Proposed design changes following consultation:

Proposed design changes following consultation:

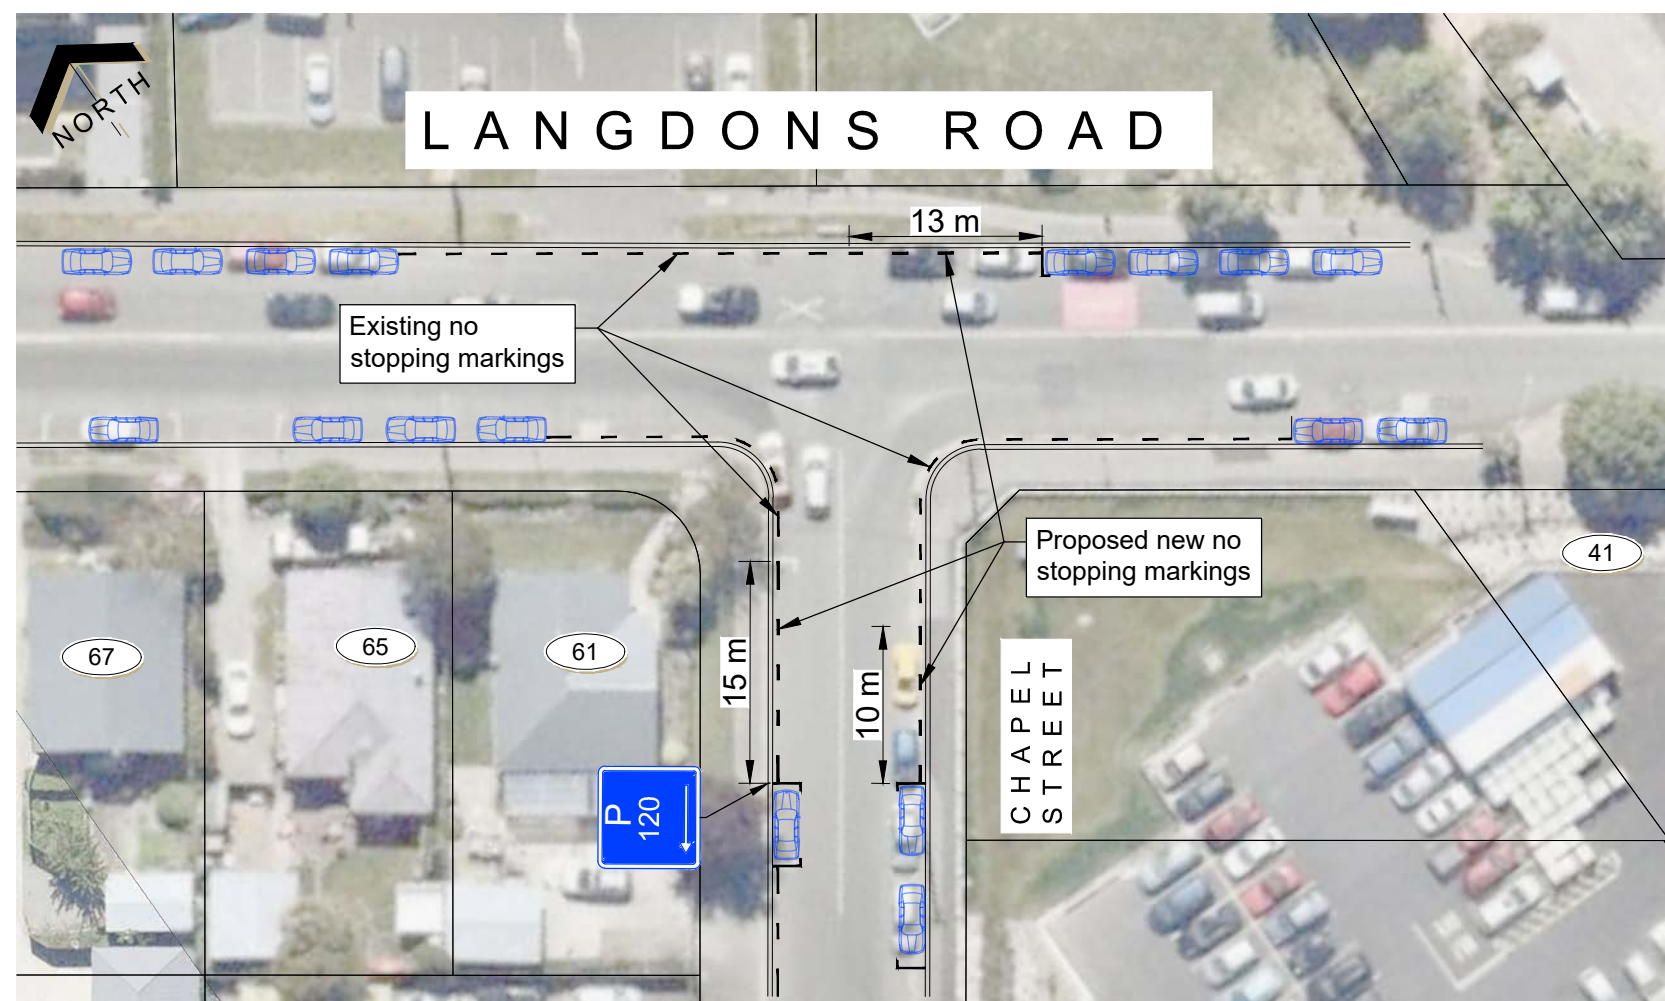
1 The shared path areas where Wilmot Street intersects with Hoani Street are replaced with direct cycle connections to the roadway.
